SUBJECT: Submits response to NRC RAI, dtd 990129 re W* SG tube repair criteria. Util proposes to limit implementation of W* SG tube repair criteria to two operating cycles for each unit. Attachments D & E provide proposed TS page.

Docket No. 50-275, OL-DPR-80
Docket No. 50-323, OL-DPR-82
Diablo Canyon Units 1 and 2
Response To NRC Request For Additional Information, Dated January 29, 1999,
Regarding Proposed W* Steam Generator Tube Repair Criteria

**RESPONSE TO NRC REQUEST FOR ADDITIONAL INFORMATION,
DATED JANUARY 29, 1999, REGARDING PROPOSED W*
STEAM GENERATOR TUBE REPAIR CRITERIA**

FIGURE 1

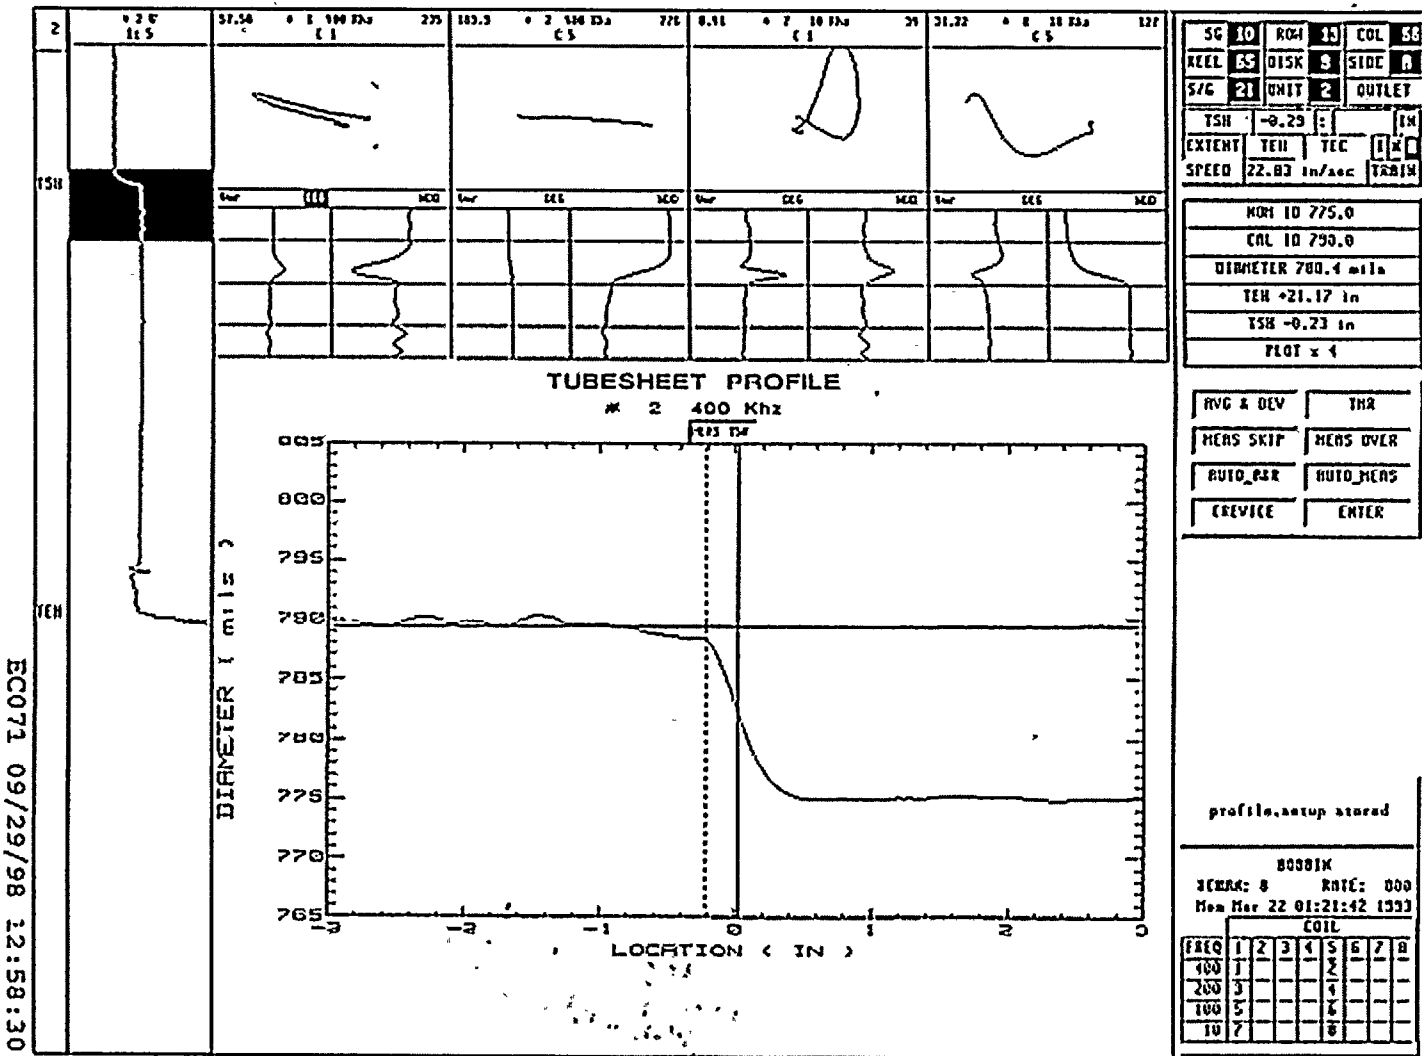
In the submittal dated October 22, 1998, it was stated the BWT would be redefined to be within 0.7 inches of the tube-to-tubesheet contact point "when profiles such as Figure 2-4 are identified." Describe, in further detail, the criteria that will be followed to redefine the BWT.

The profile plots, such as Figures 1 and 2, provide the basis for classifying the signals based on the intersection of the extrapolated profile and the bobbin coil profile. Classifications from A to C have been defined to assist in NDE analyst training.

Class A tubes have no identifiable taper below the BWT (i.e., essentially ideal profiles). Figure 2-1 in PG&E Letter DCL-98-148 is an example of a Class A expansion.

Figure 1. Loss Coefficient vs Contact Pressure - Sample W4-001

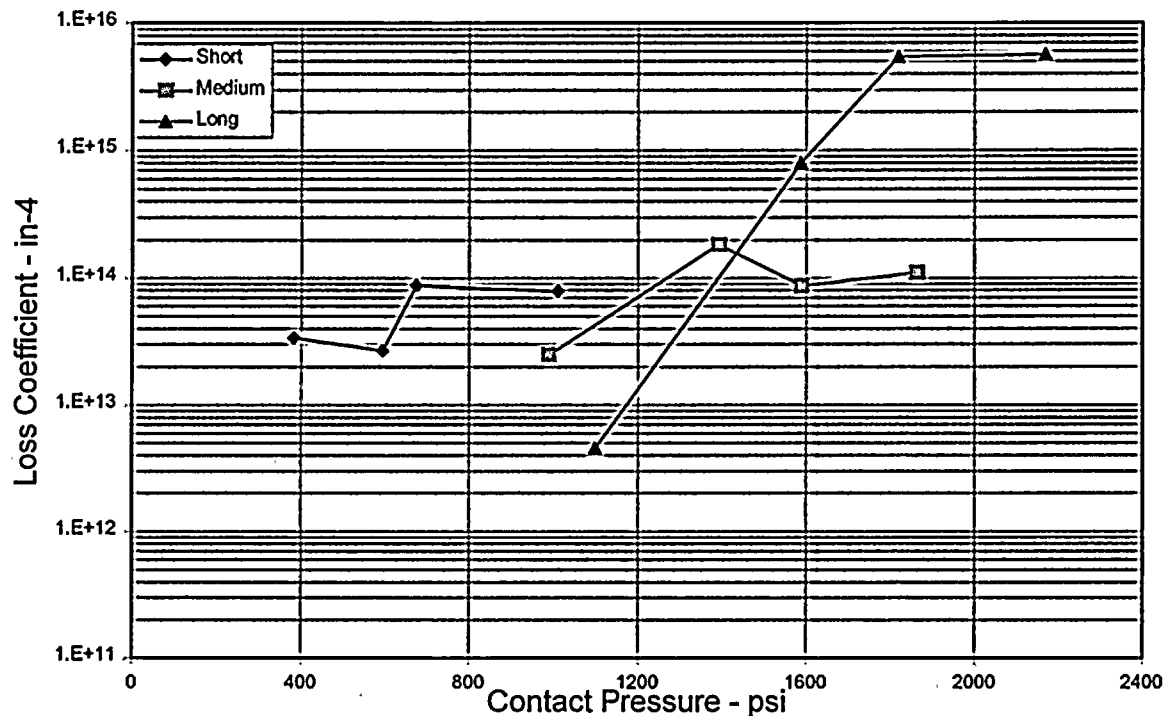
“Attached are copies of some Excel graphs I made to investigate the possibility of specimen dependence on the unusual scatter evident in Figure 6.4-2 of the W* topical report. I first separated the data into four groups by specimen ID, i.e., W4-001, W4-004, W4-008, and W4-018. Then I broke down the data in some of the groups into three subgroups (short, medium and long). Short medium and long specimens are those with crevice lengths on the order of 0.5”, 1”, and 2” respectively. As you can see from the attached figures, tests of W4-004 specimens and W4-018 clearly demonstrate that something unusual has cropped up in the test results. Please look at this and get back to me with your conclusions. Feel free to call me to discuss this observation.”

Mr. Rush's plots of the data, separated by sample number and crevice length, were re-plotted using the correct data set. These plots appear as Figures 1 through 4. Except for a few of the points, the plots have the same appearance as Mr. Rush's with the loss coefficient scale an order of magnitude lower. The data scatter on Figures 1 through 4 is consistent with the scatter on Figure 6.4-2 of Reference 1. Recall that the data appear to have constant variance about the regression line of Reference 1 and do not contradict the assumption of normality for the distribution of the residuals from the regression analysis.

On the surface, Figure 2 (for Sample W4-004) and to a lesser degree, Figure 4 (for Sample W4-018) seem to indicate that loss coefficient is increasing with decreasing crevice length. Samples W4-001 and 008 do not show this pattern. Figures 5 through 8 re-plot the same loss coefficient data sets versus crevice length with operating conditions as a parameter. When viewed in this manner, the data shows no consistent trend of loss coefficient variation with length. Sample WP4-001 shows a general increase of loss coefficient with length although one set of operating conditions shows the reverse trend. The medium lengths for Sample WP4-004 have lower loss coefficients than the short lengths, but the trend is reversed for the single set operating conditions tested at the long length. Sample WP4-008 shows a general increase of loss coefficient with length. Sample WP4-018 shows a decrease of loss coefficient with length for the medium and long lengths, but the reverse trend for the single case of short and medium length tested.

Figure 2. Loss Coefficient vs Contact Pressure - Sample W4-004

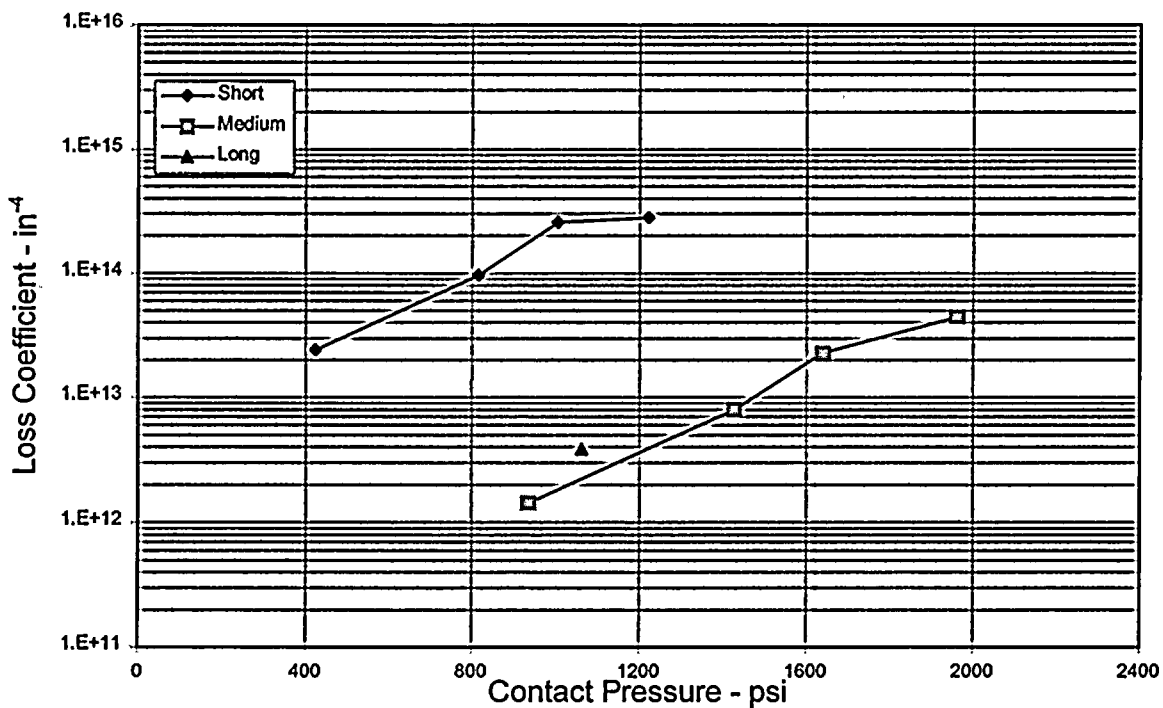
The information plots transmitted by Mr. Rush depicted data from Reference 2, which was prepared in response to earlier RAIs and updated Table 6.2-3 of the WCAP to include calculated loss coefficients (flow resistance) for the test specimens. The essence of Mr. Rush’s concern is summarized as “... tests of W4-004 specimens and W4-018 clearly demonstrate that something unusual has cropped up in the test results.” The “something unusual” to which Mr. Rush refers is apparently that the loss coefficient appears to be dependent on crevice length. Physically, the loss coefficient should be independent of the length of the crevice.

**Figure 5. Loss Coefficient vs Crevice Length
Sample WP4-001**

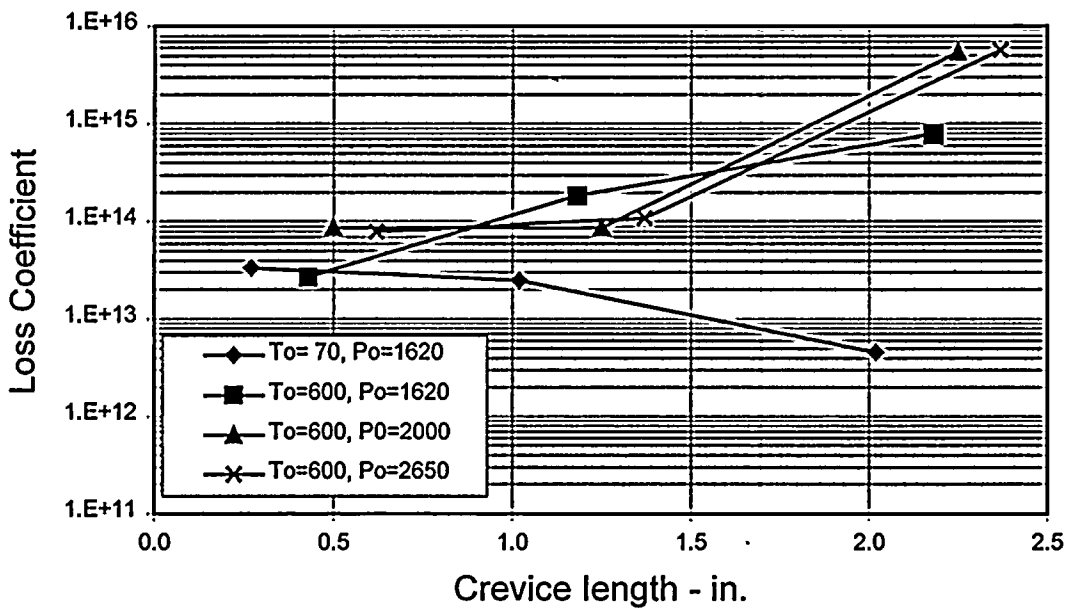
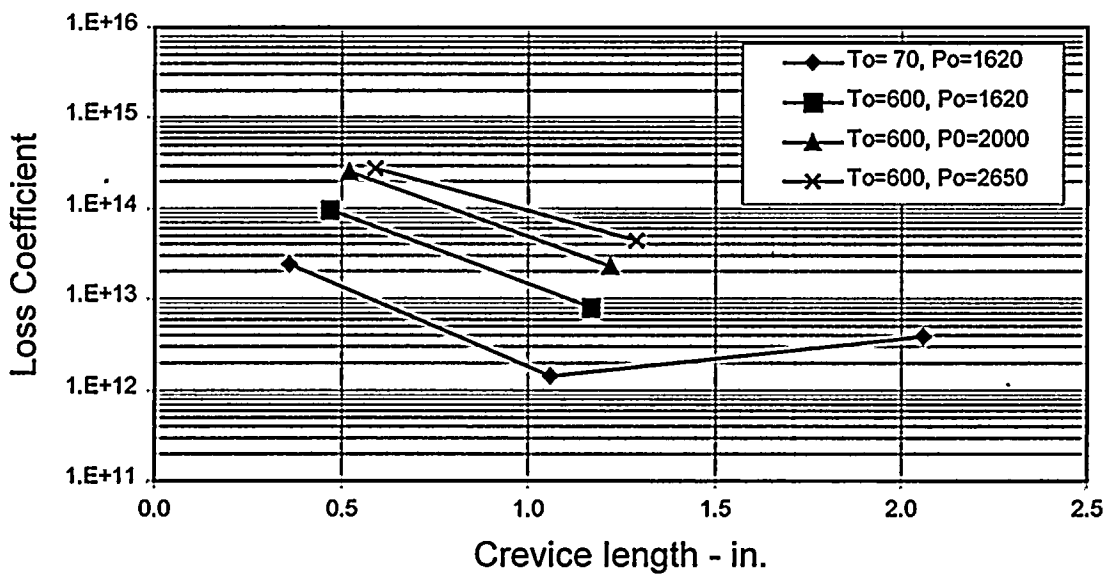
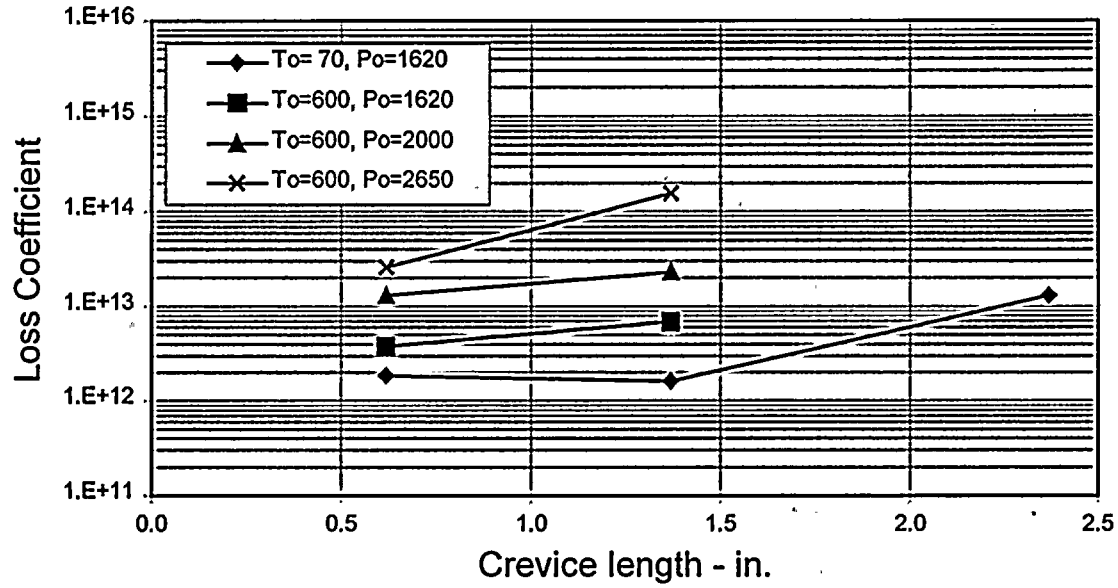
By letter dated August 28, 1998, the licensee submitted leak rate test data for the proposed W steam generator tube repair criteria. The staff's evaluation of this data has concluded that the measured leak rates are functionally dependent on the crevice length. For example, the figure [in the RAI] illustrates the dependence of the loss coefficient obtained from leak rate measurements on the crevice length. As seen in the data, different correlations are evident for the three general categorizations for the crevice length. This dependence, however, varies with each sample number (e.g., W4-018). Based on information provided in WCAP-14797, Revision 1, the crevice leak rate model proposed for W* does not account for this variable. Discuss the root cause for the dependence of the measured leak rate on the specimen crevice length. Also, discuss whether the model will provide accurate (or conservative) estimates of leakage from W* tubes given that crevice lengths were not accounted for in the model relating the contact pressure to the loss coefficient.*

The above review of the loss coefficient data for WEXTEX crevices shows no consistent length effect. The absence of a length effect is expected based on physical grounds.
